Traditions II - Block 349 Medium Density

Servicing and Stormwater Management Report

**Reference: 1883 Stittsville Main
Response to First Formal Review Comments (D07-12-24-0142)
Our File No.: 124097**

PROJECT No.	124097
REV	REV # 10
DRAWING No.	124097-GR

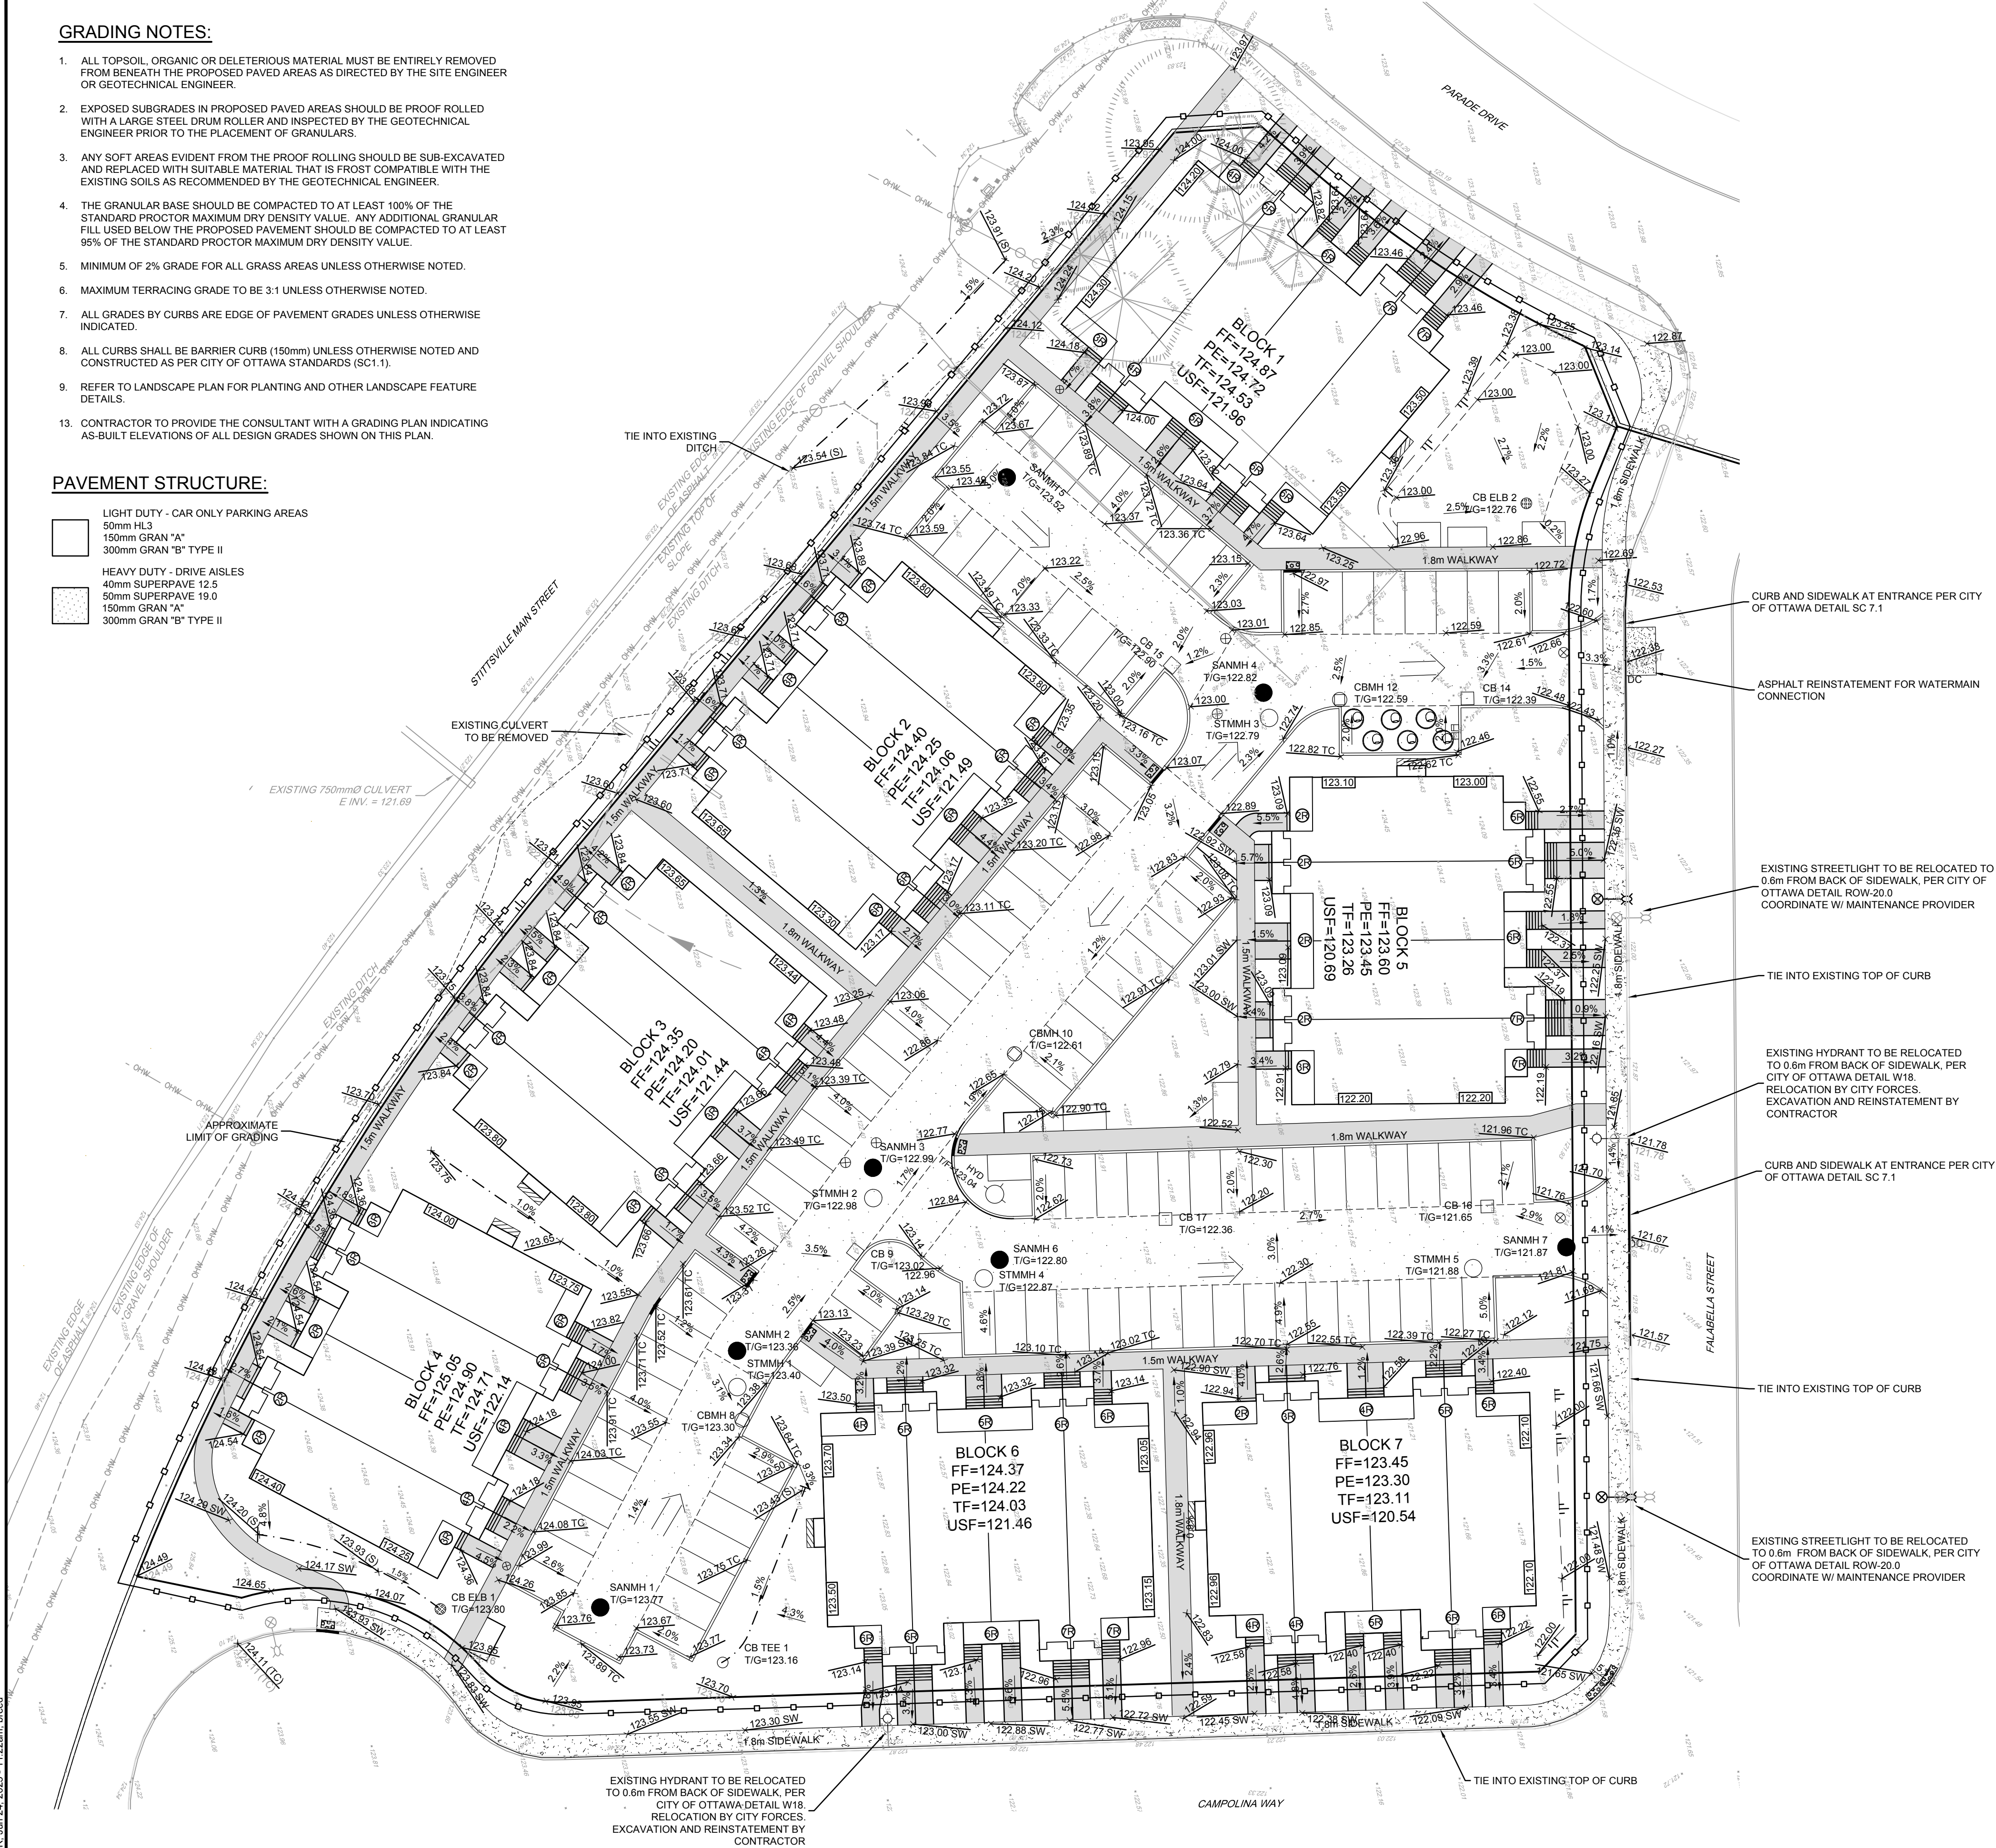
24. If the Grading Plan will serve as the ESC Plan as well, please ensure the title of the drawing notes *Grading Plan and Erosion and Sediment Control Plan*, or similar. Please add ESC notes to the drawing.

25. Please add additional grades/slopes between Block 3 and Block 4.

Response: Plan revised

Response: Plan revised

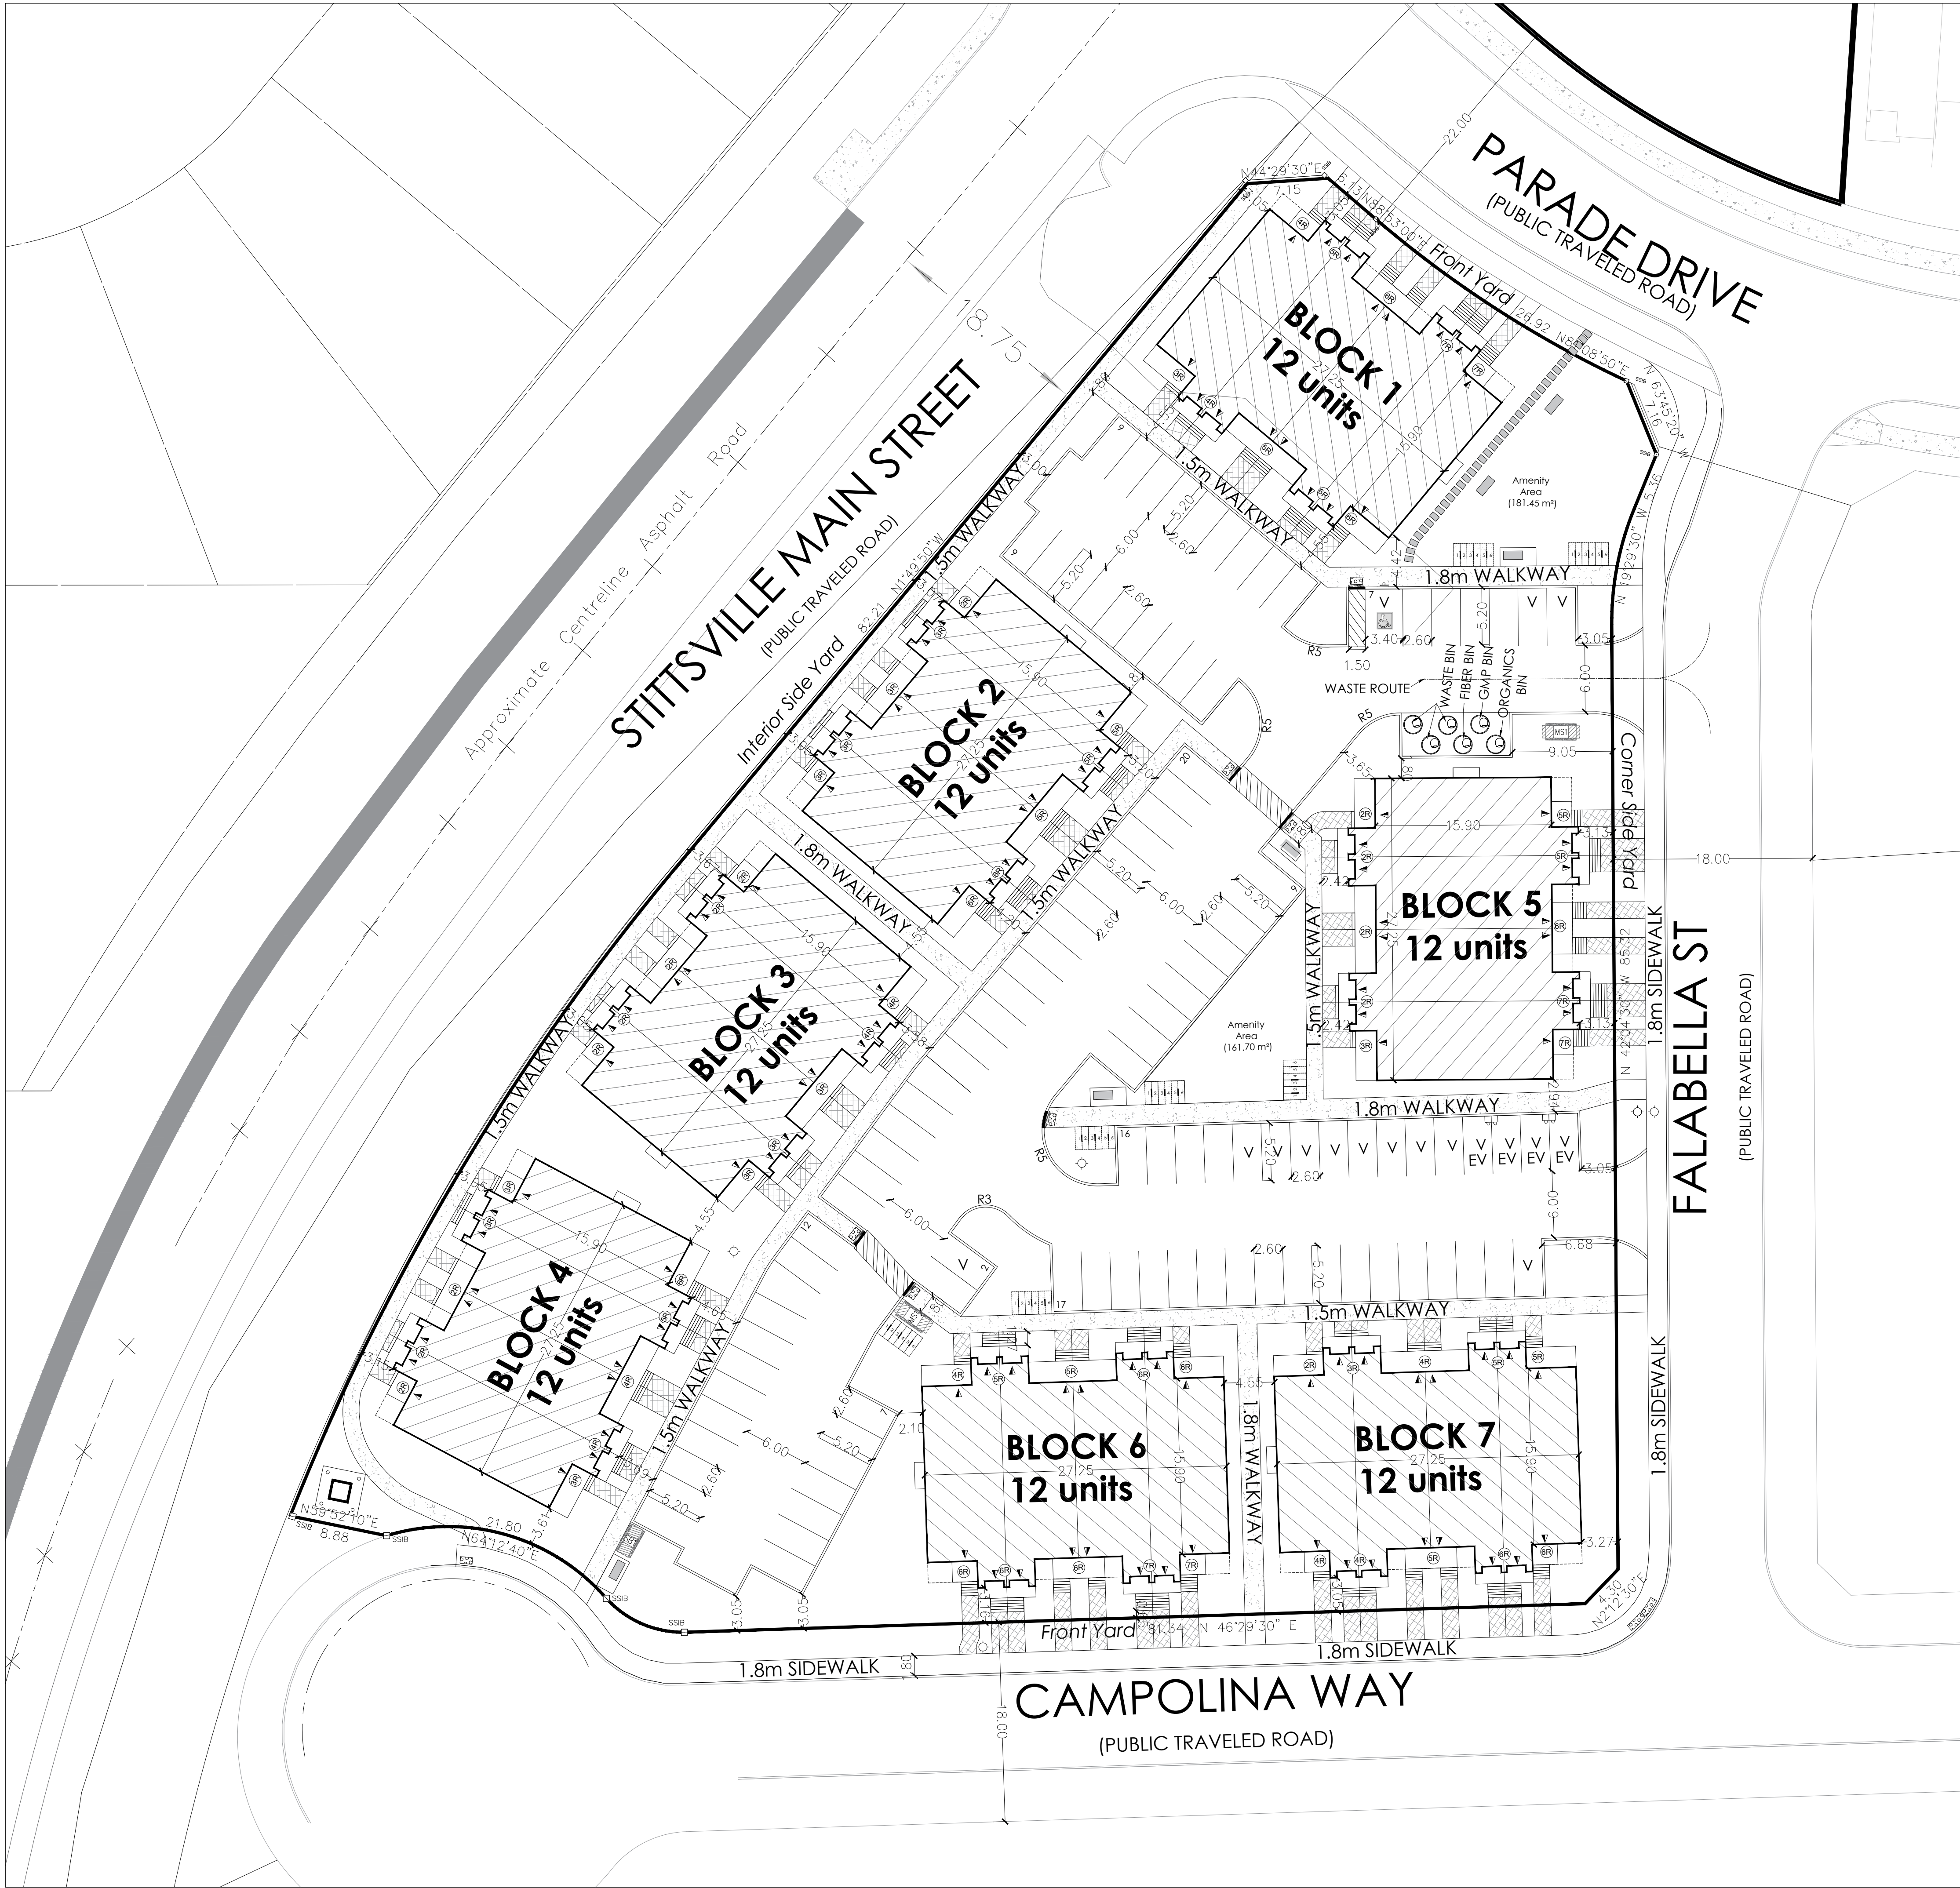
1. List the revision numbers on the site plan.

6. Please review opportunities to provide a pedestrian crossing connection and depressed curb connecting the east walkways to the west.

Response: Site Plan revised.

Response: Shown on the revised Site Plan.
